**Subject** Change Order No. 2, Lease-Leaseback Contract – Cahill Contractors LLC– Fremont High School Modernization Project– Division of Facilities Planning and Management

# CHANGE ORDER

| Project: | Fremont Modernization |

DESCRIPTION OF AGREED CHANGES IN WORK OR CONTRACT (refer to attached pages or incorporated documents, if necessary):
Phase I & II: Various Change Requests PCOs 2- 12

Sheet
2-L8.01

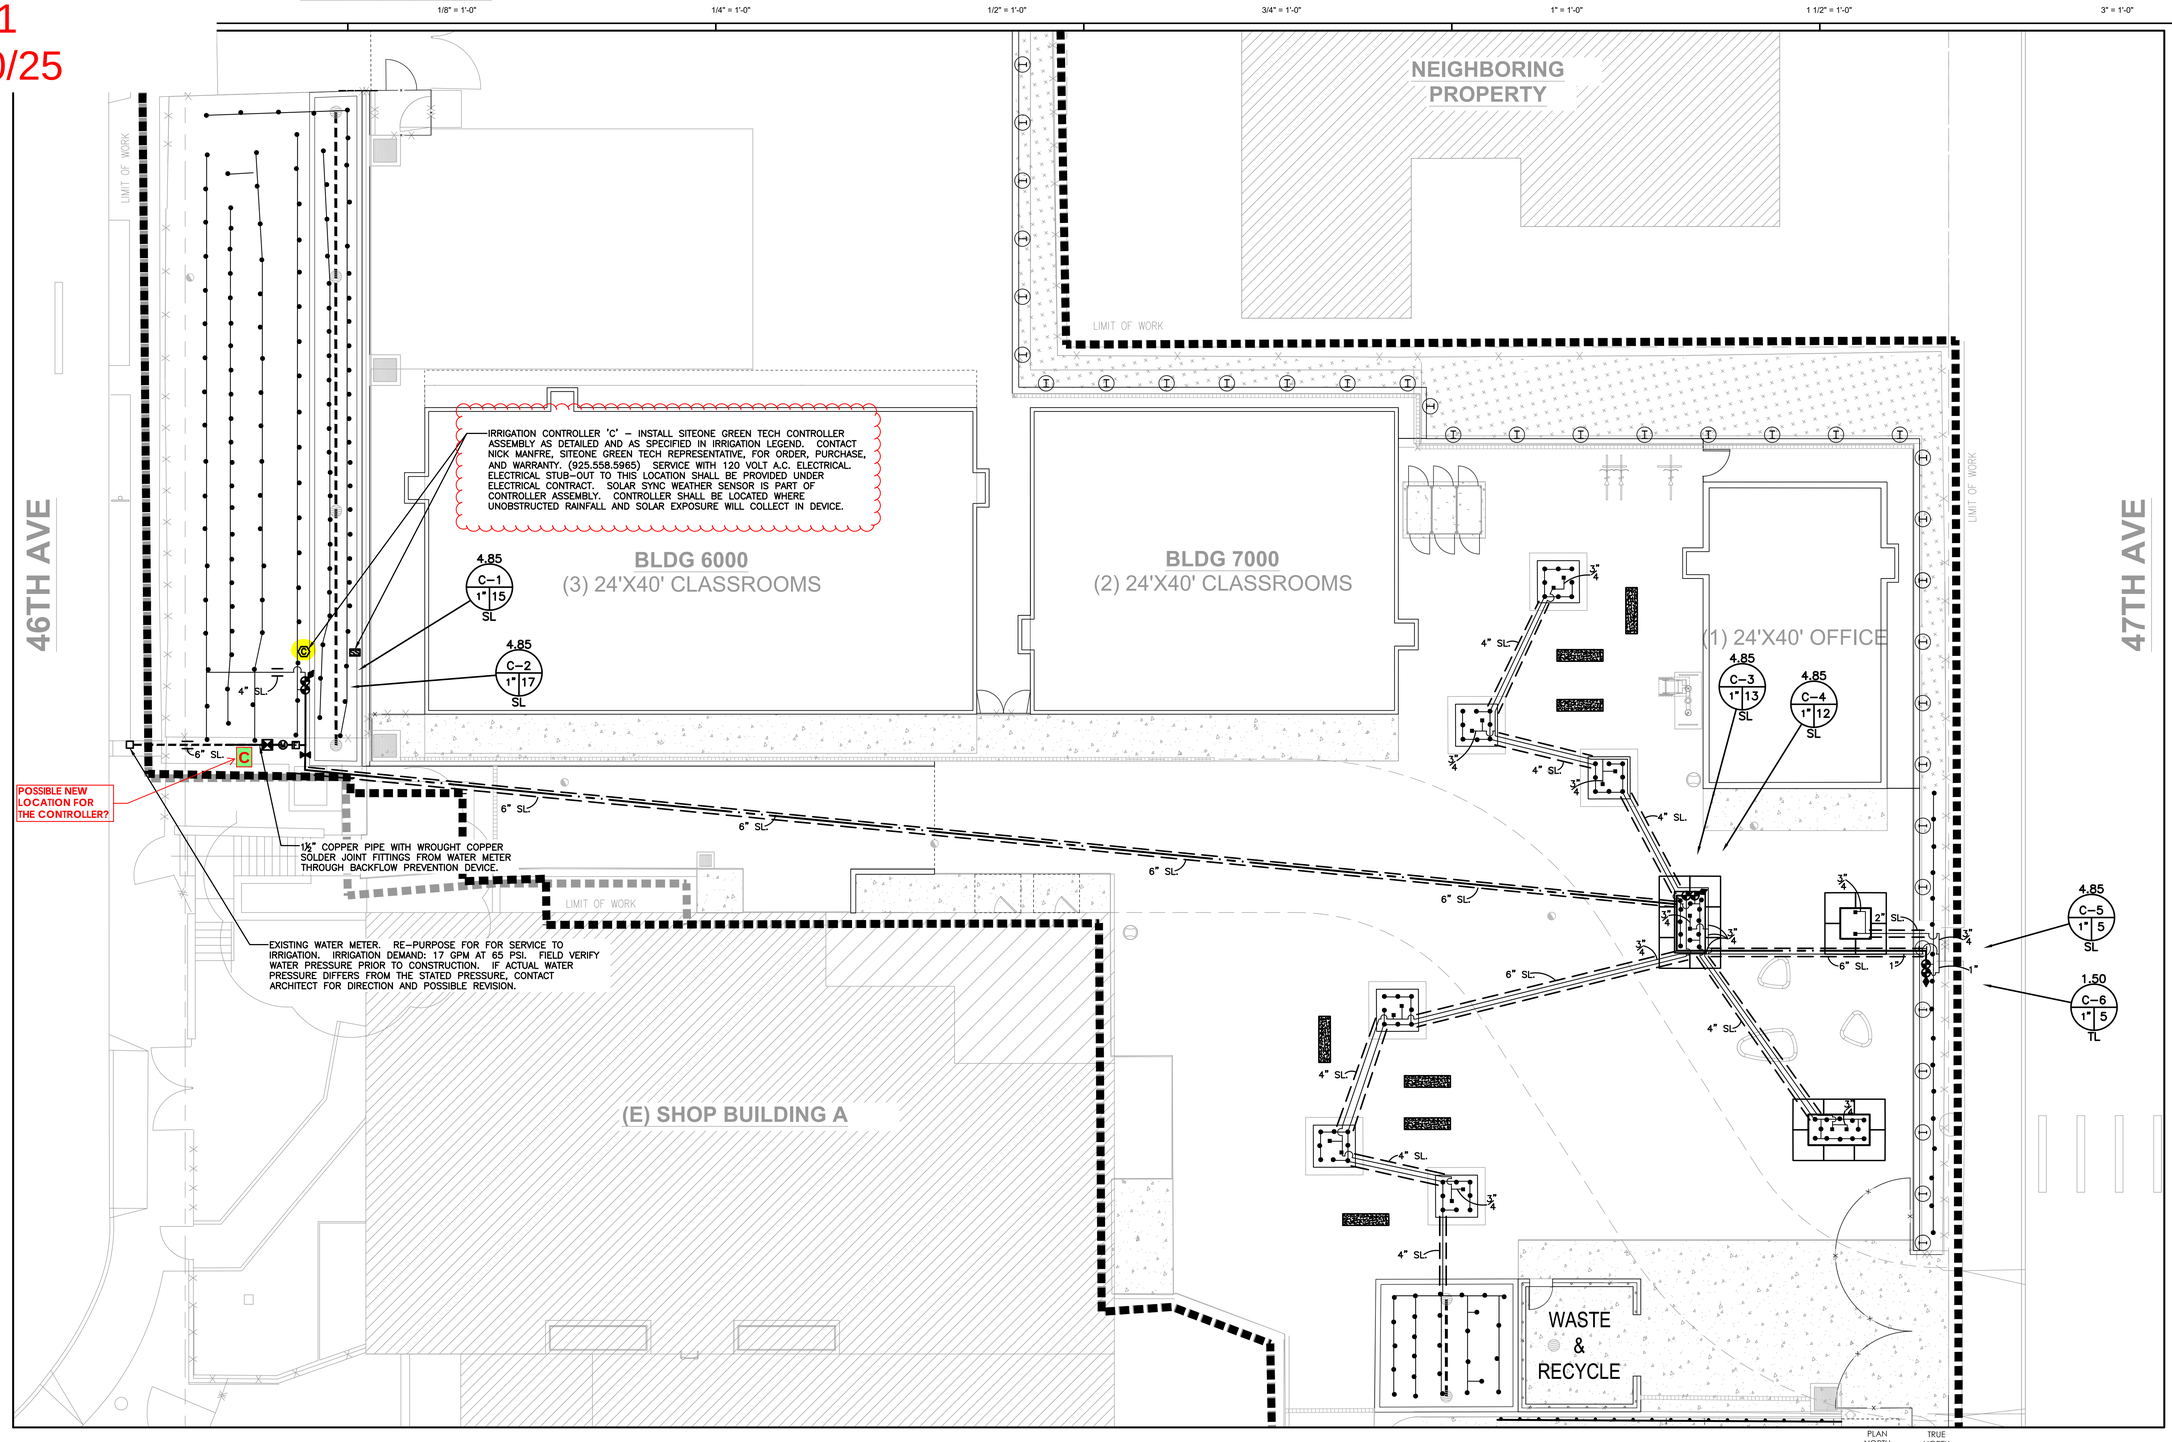
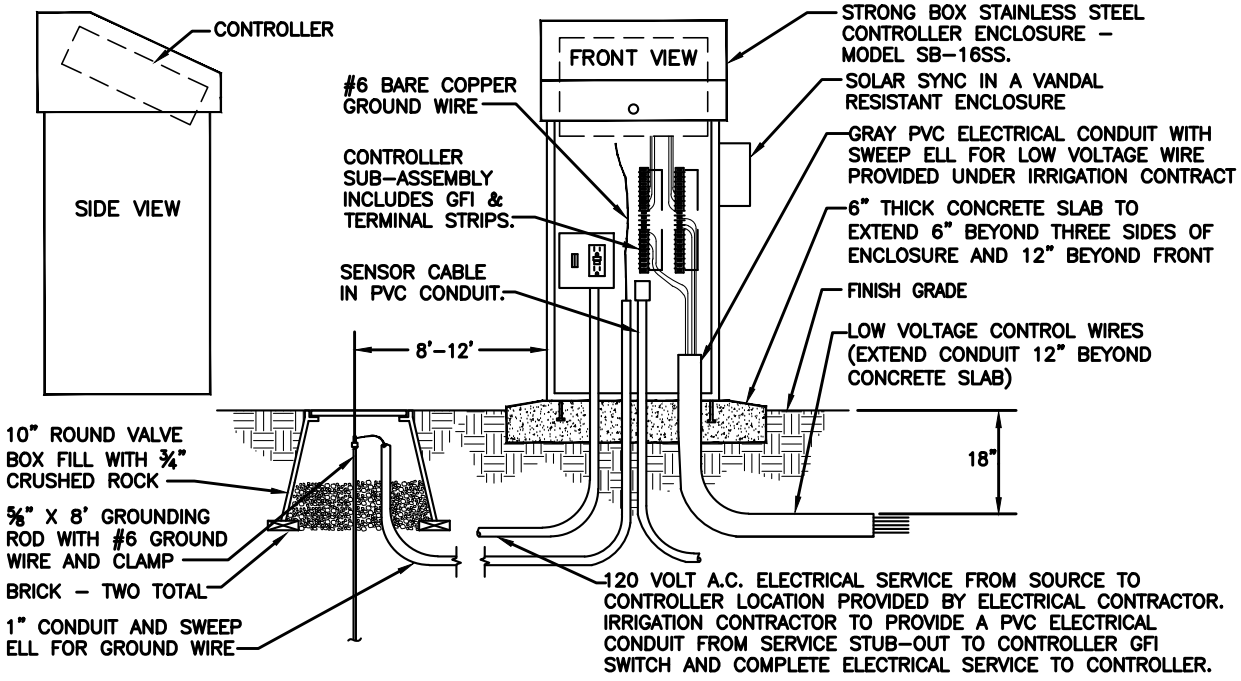
2-L8.01 calls for an irrigation controller to be installed in the bioretention planter which is to be connected to 120 Volt A.C. electrical. No information is provided for the controller on the electrical drawings.

Sheet: 2-E2.01

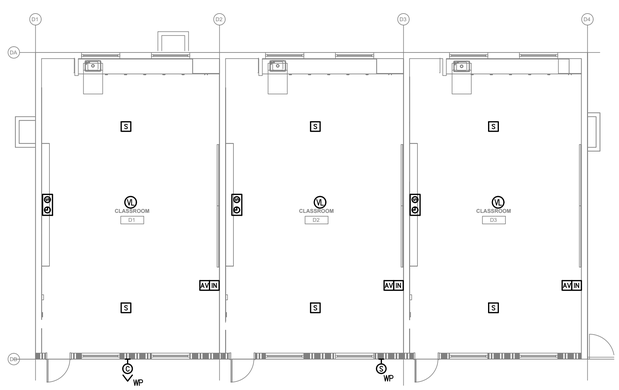
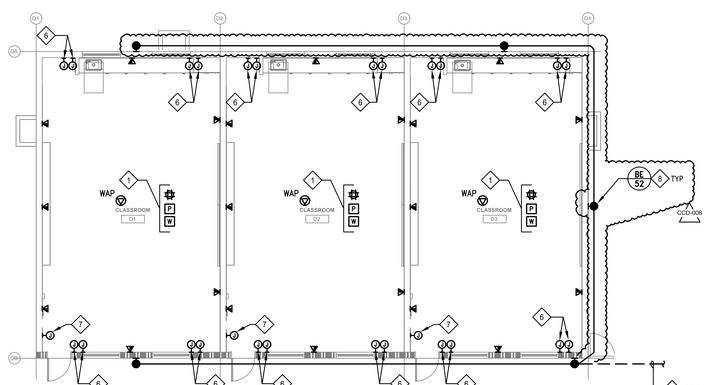
Drawing 2E2.01 shows a number of exterior wall mounted emergency light fixtures on the exterior of the modulars. No callout indicates what these fixtures are, and they do not match the quantity and placement of the exterior emergency light fixtures shown on the modular electrical plans.

RFI 98 - Phase 2
1/29/26
SK-01

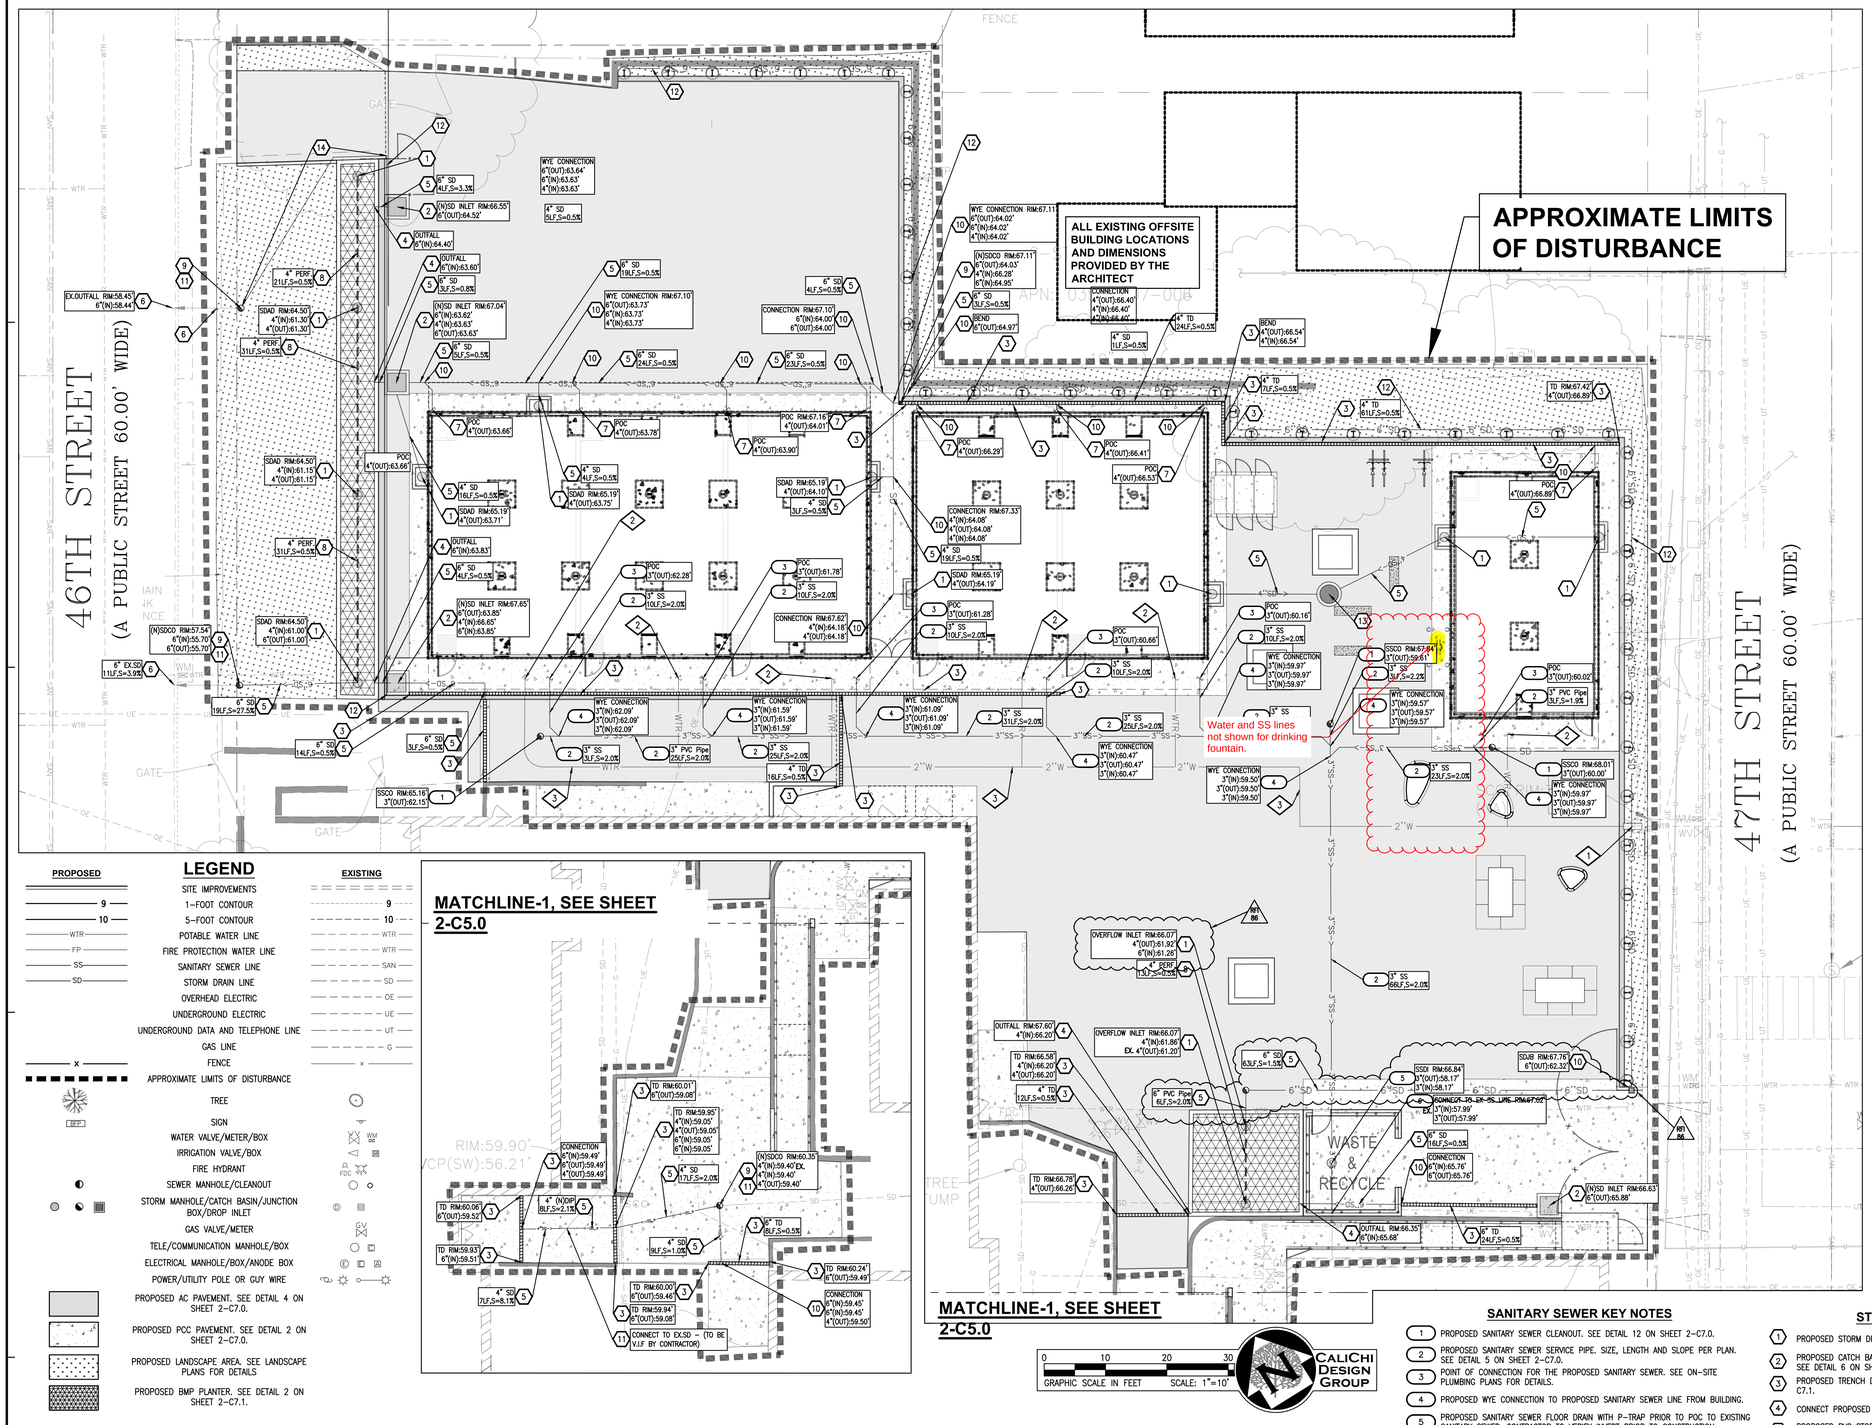
2-L4.01 calls for a drinking fountain to be installed alongside building 8000. 2-C5.0 shows the drinking fountain on the civil utility plan, but does not show domestic water or SS lines going to the drinking fountain.

**Attachments**
RFI 99 Additional Detail.pdf

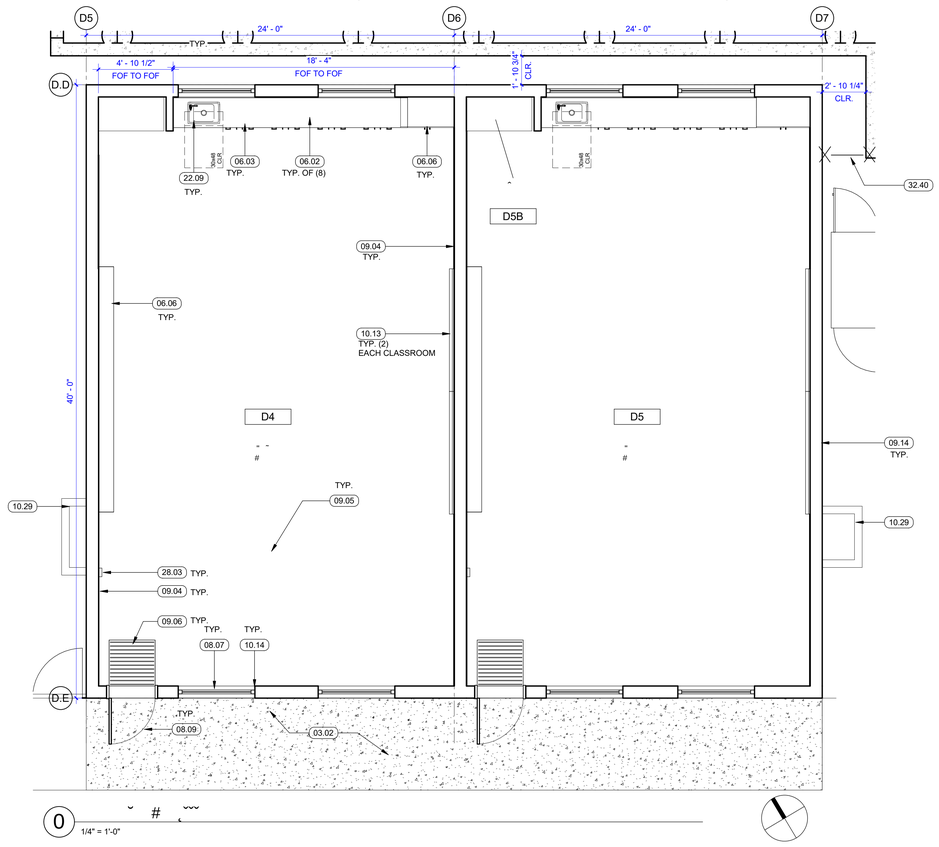
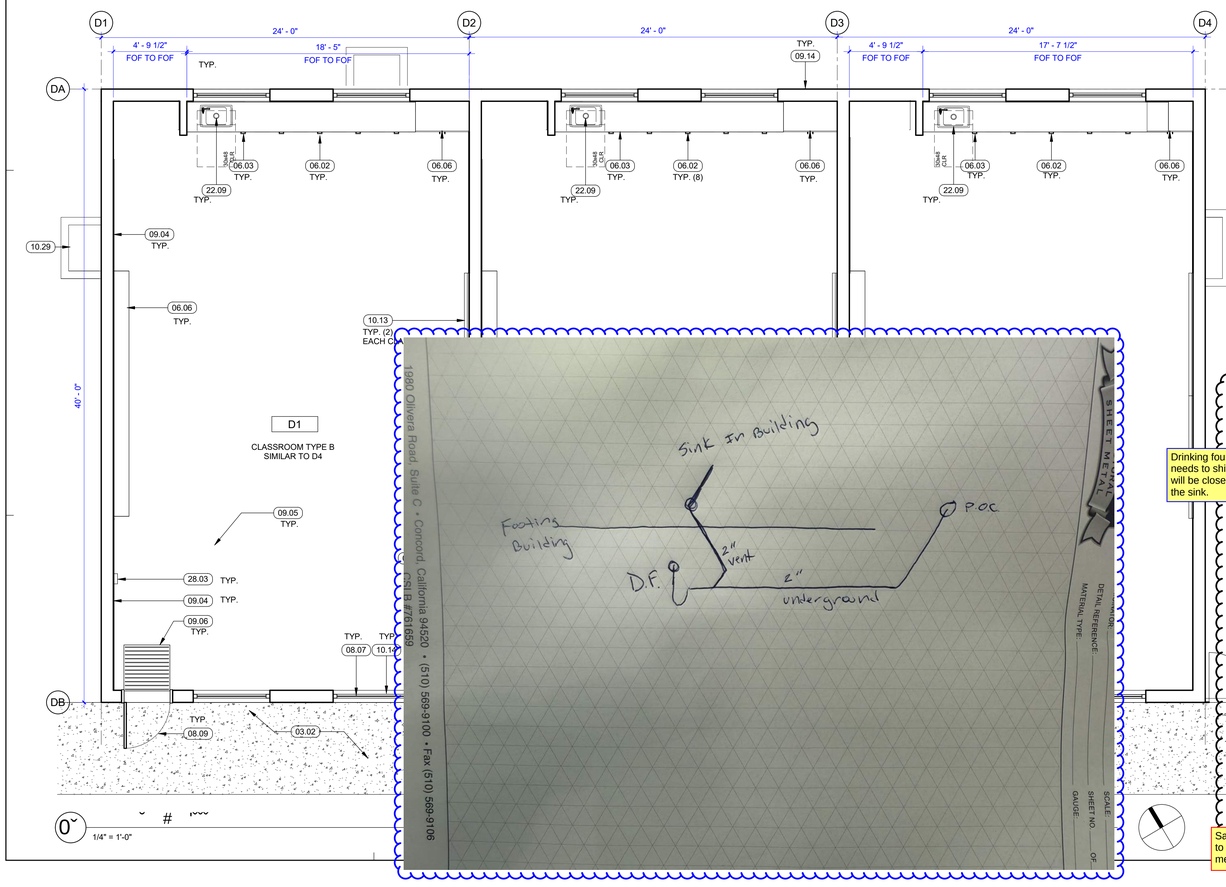
2-L4.01 calls for a drinking fountain to be installed alongside building 8000. 2-C5.0 shows the drinking fountain on the civil utility plan, but does not show domestic water or SS lines going to the drinking fountain.

Per discussions with Cahill, the drinking fountain plumbing lines can be connected to the CW and SS lines of Building 8000. The SS line of the drinking fountain being connected to the building's SS line will require a vent to extend 10' above grade. Contractor to confirm size of existing vent for the sink in order to tie into that existing vent.
